EXCAVATION AND FLOOD PROTECTION - 17TH STREET CANAL CAPPING OF FLOODWALLS EAST SIDE LEVEE IMPROVEMENTS

AMENDMENT OF SOLICITATION/MODIFICATION OF CONTRACT 1. CONTRACT ID CODE PAGE OF PAGES
1 8

2. AMENDMENT/MODIFICATION NO. 0002	3. EFFECTIVE DATE 05/28/93	4. REQUISITION/PURCHASE REQ. NO. ED0000-3336-0063	5. PROJECT NO. (If applicable) dkn
6. ISSUED BY US ARMY ENGR DIST NEW ORLEANS PO BOX 60267 NEW ORLEANS LA 70160-0267 Molly M. Block		7. ADMINISTERED BY (If other than Item 6) US ARMY ENGR DIST, NEW ORLEANS ATTN CELMN-CT PO BOX 60267 NEW ORLEANS LA 70160-0267	
CODE ISSUE1		CODE ADMIN1	
SC2 (504)862-2879

PLANS AND SPECIFICATIONS FOR LAKE PONTCHARTRAIN LA & VICINITY, HURRICANE PROTECTION PROJECT, HIGH LEVEL PLAN, 17TH ST. OUTFALL CANAL, FLOOD PROTECTION IMPROVEMENT PROJECT, CAPPING OF FLOODWALLS, EAST SIDE IMPROVEMENTS, ORLEANS PARISH, LA, ARE HEREBY AMENDED AS FOLLOWS:

**SIGNING PLAN -
DURING OPERATIONS NORTH OF HAMMOND HWY.**
SCALE: 1"= 200'-0"

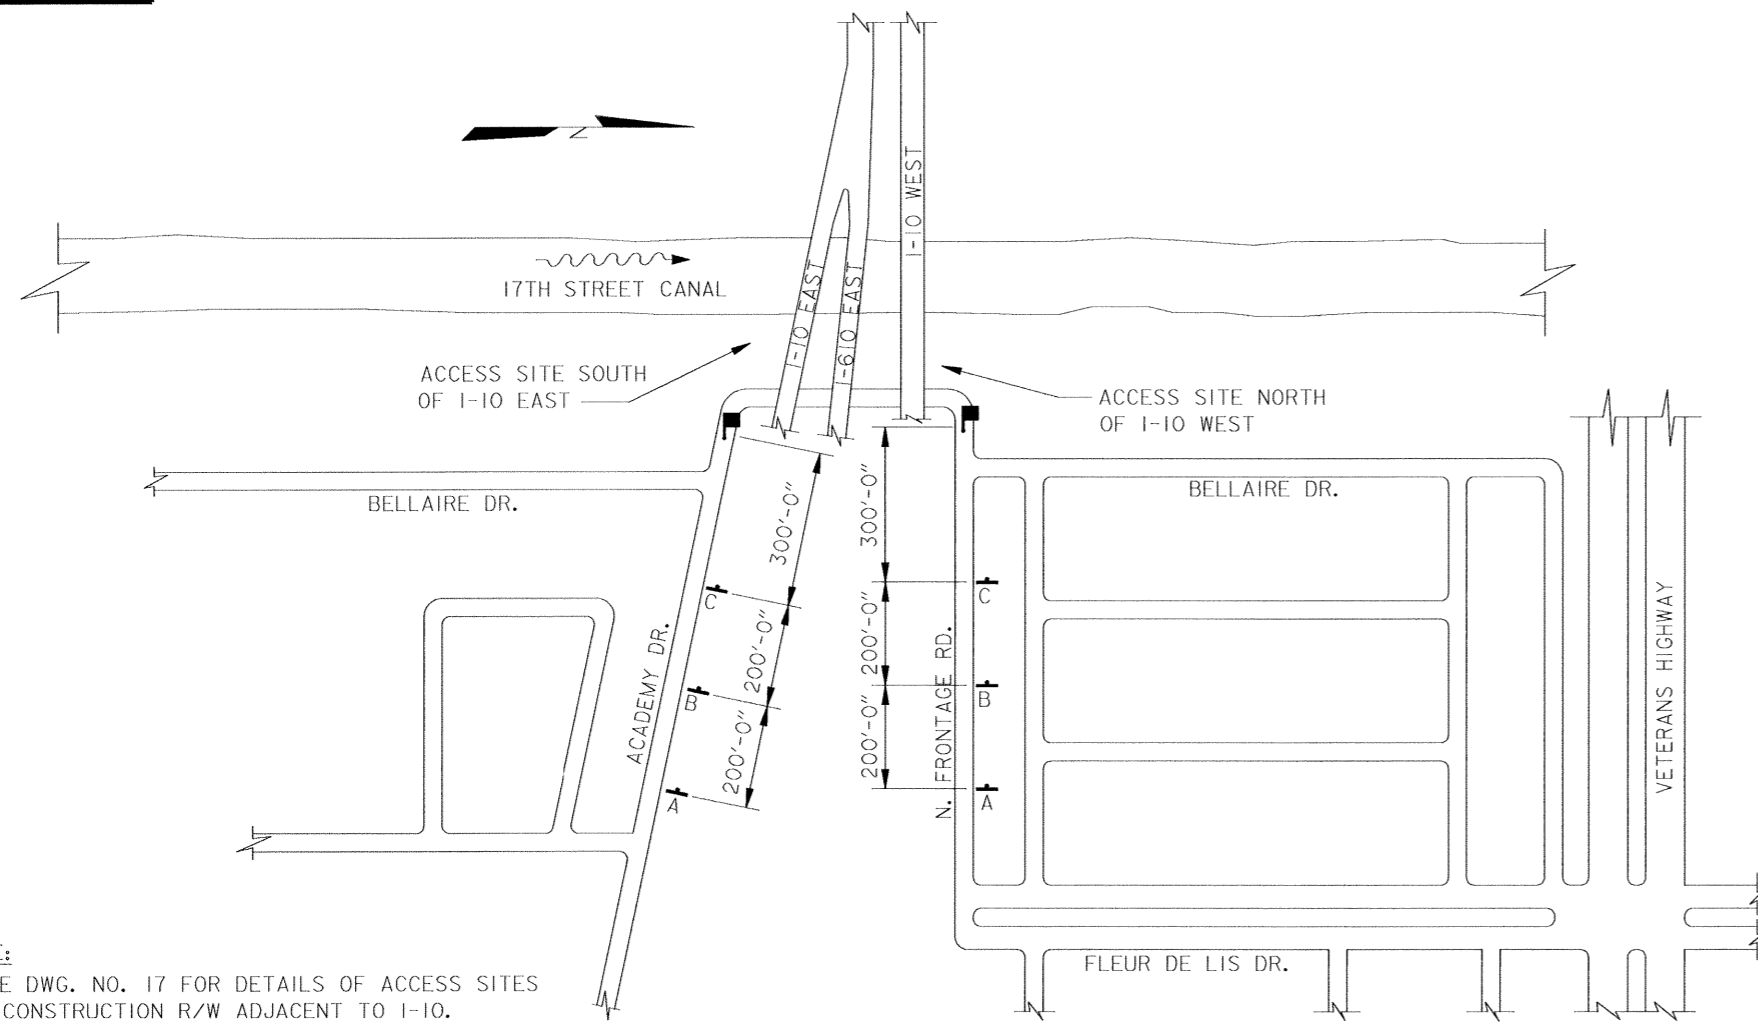
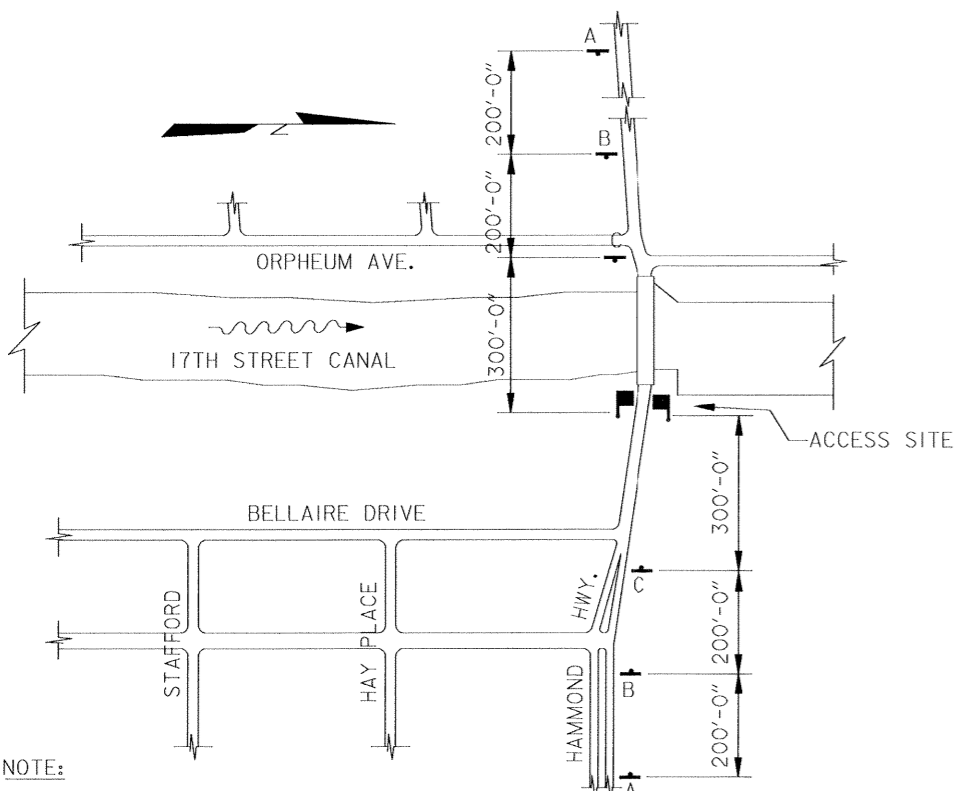
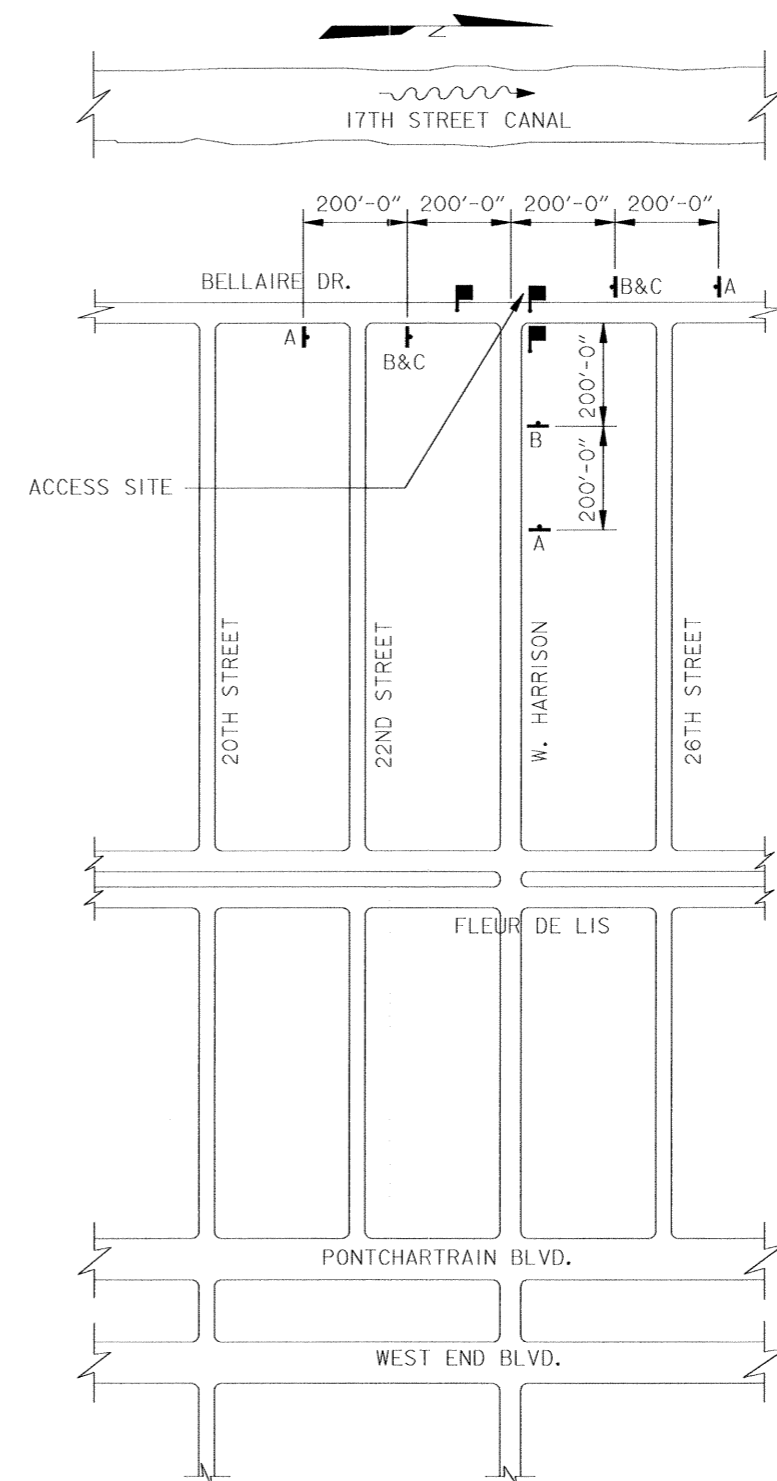
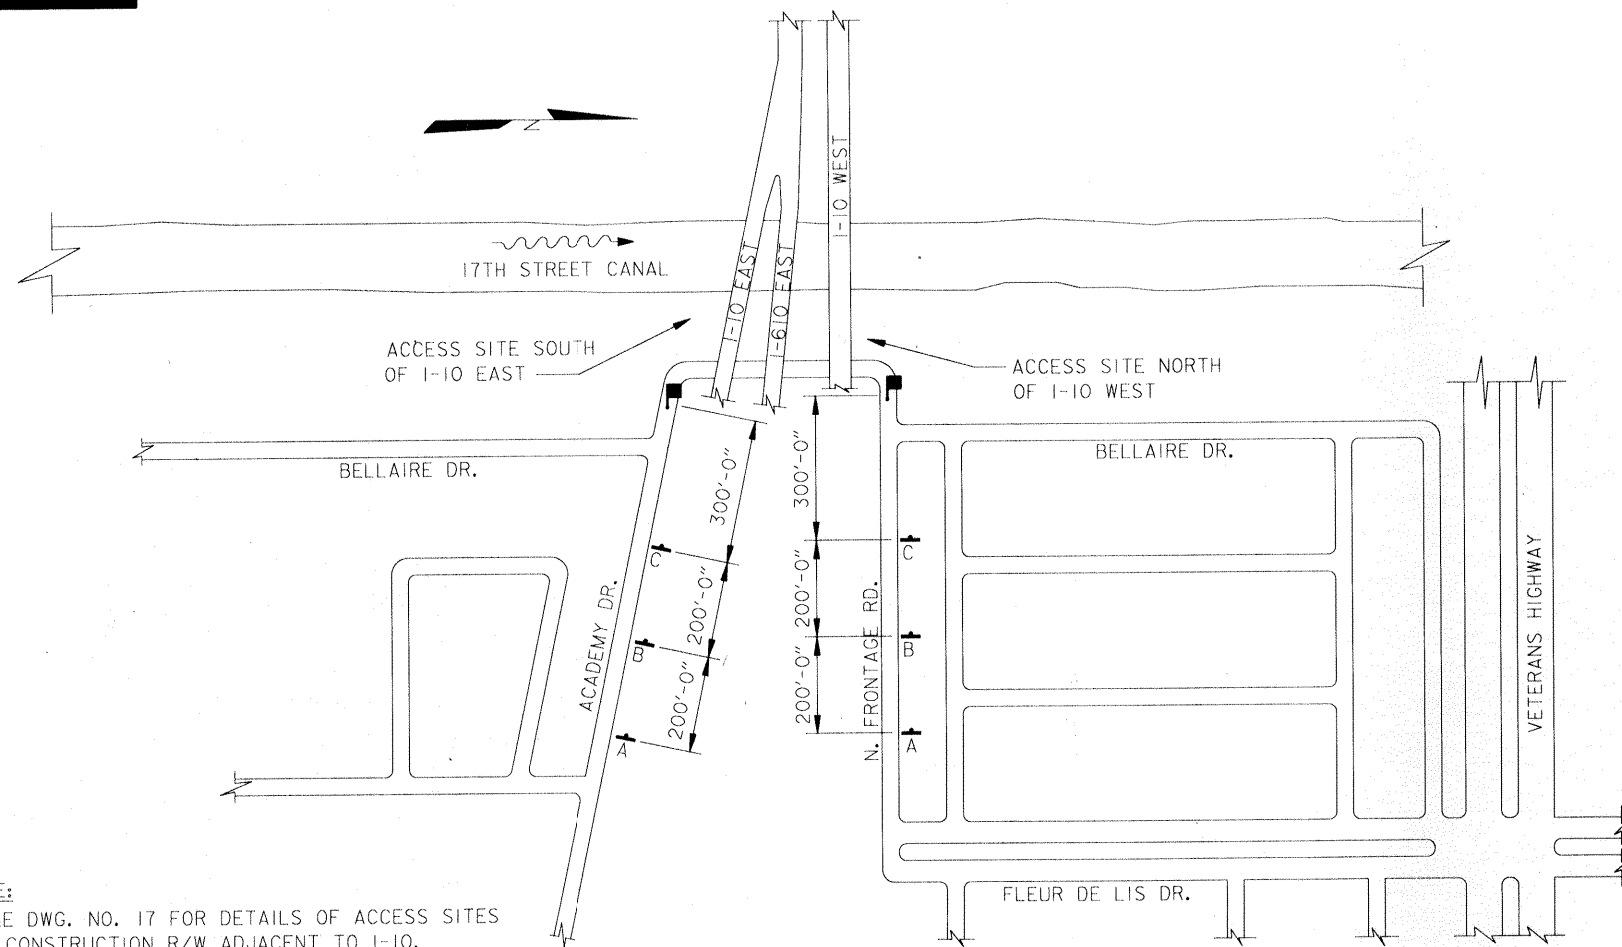
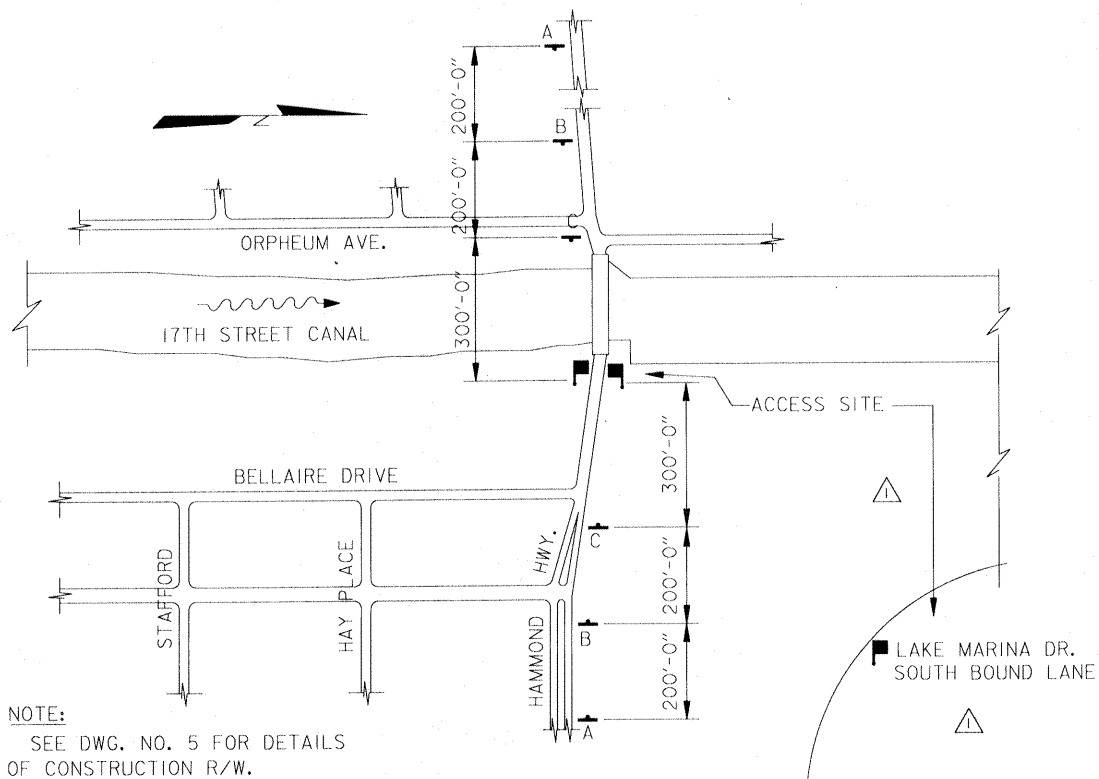
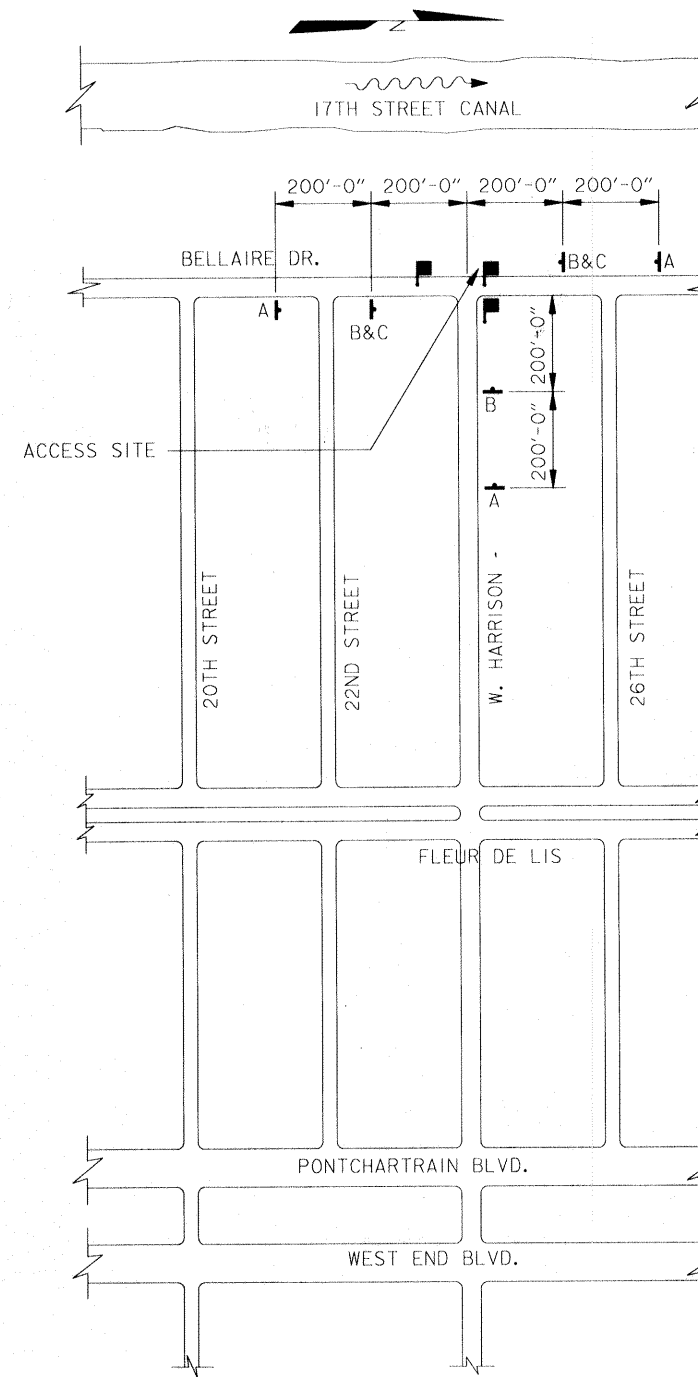
ADDED NORD PLAY GROUND & LAKE MARINA DR. SOUTH BOUND LANE. AMEND. #2 5/24/93 R.J.C.			
SYMBOL	DESCRIPTION	DATE	APPROVED
REVISIONS			
U.S. ARMY ENGINEER DISTRICT, NEW ORLEANS CORPS OF ENGINEERS NEW ORLEANS, LOUISIANA			
BOARD OF LEVEE COMMISSIONERS ORLEANS LEVEE DISTRICT NEW ORLEANS, LOUISIANA		MODJESKI & MASTERS INC. NEW ORLEANS, LOUISIANA	
LAKE PONTCHARTRAIN, LA. AND VICINITY HIGH LEVEL PLAN 17TH STREET CANAL EXCAVATION AND FLOODWALL PROTECTION CAPPING OF FLOODWALLS EAST SIDE LEVEE IMPROVEMENTS ACCESS SITES AND TRAFFIC CONTROL-1			
DESIGNED BY: F.S.	DATE: NOV. 1992	PLOT SCALE: 2400	PLOT DATE: APR 1993
DRAWN BY: P.M.R.	CHECKED BY: M.L.S.	CADD FILE: 40208X16.DGN	FILE NO. H-4-40208
SUBMITTED BY: W. B. CONWAY MODJESKI & MASTERS, INC. DESIGN ENGINEER		SOLICITATION NO. DACW29-93-B-0025	DWG. 15 OF 16

ACCESS AND STORAGE DETAILS
STA. 40+13 TO HAMMOND HIGHWAY
SCALE 1" = 10'-0"
STORAGE ON LEVEE NOT SHOWN ON PLAN FOR CLARITY.

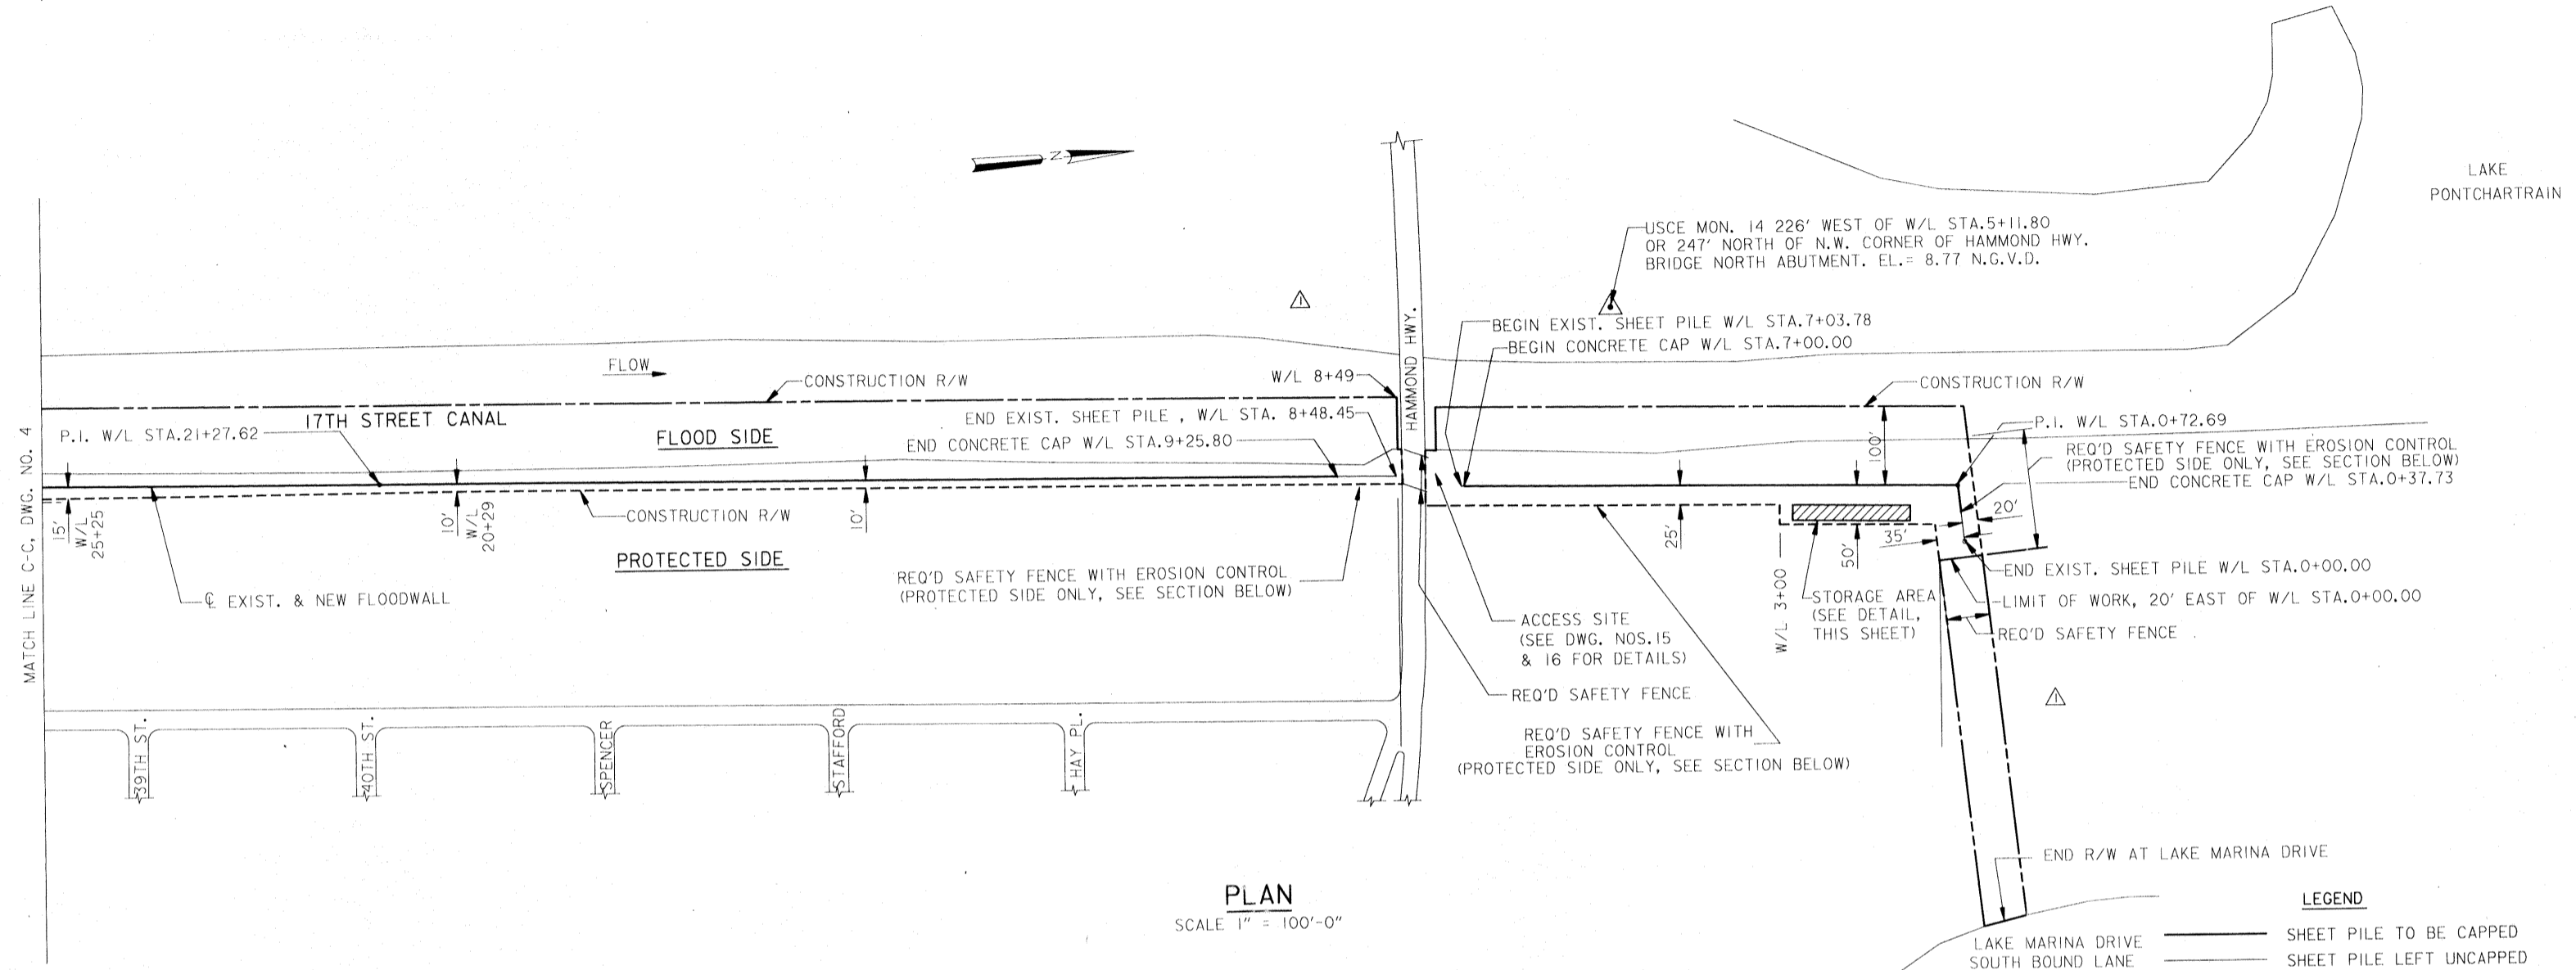
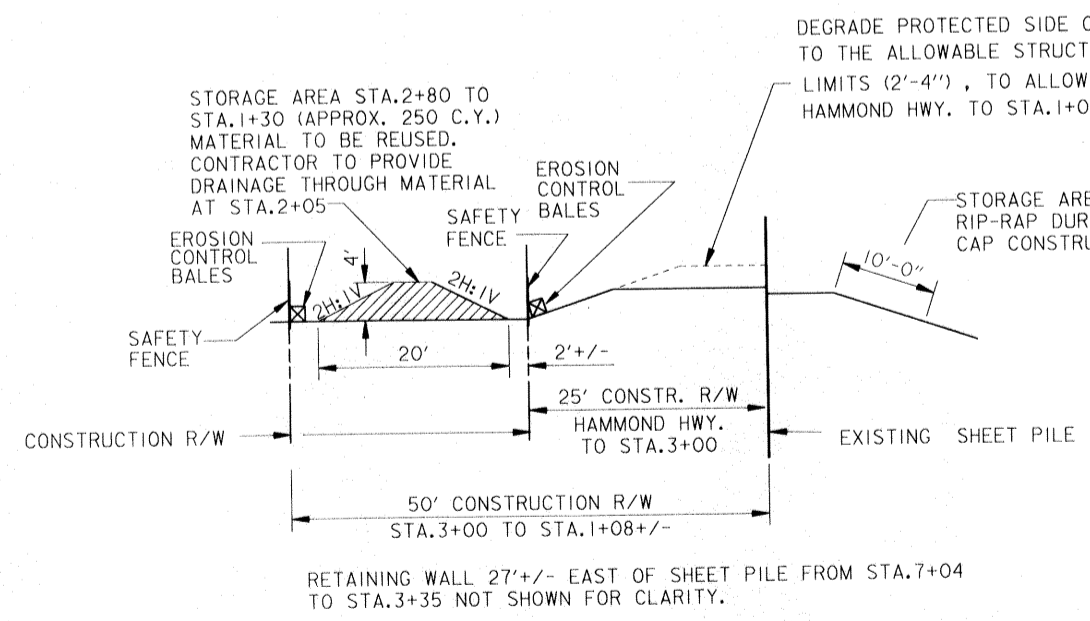
Delete Dwgs. 2, 5, 8, 9, and 15 of 17, File No. H-4-40208, in their entirety and substitute the attached revised Dwgs. 2, 5, 8, 9, and 15 of 17, File No. H-4-40208 therefor.

STORAGE AREA STA. 2+80 TO STA. 1+30 (APPROX. 250 C.Y.) MATERIAL TO BE REUSED. CONTRACTOR TO PROVIDE DRAINAGE THROUGH MATERIAL AT STA. 2+05.
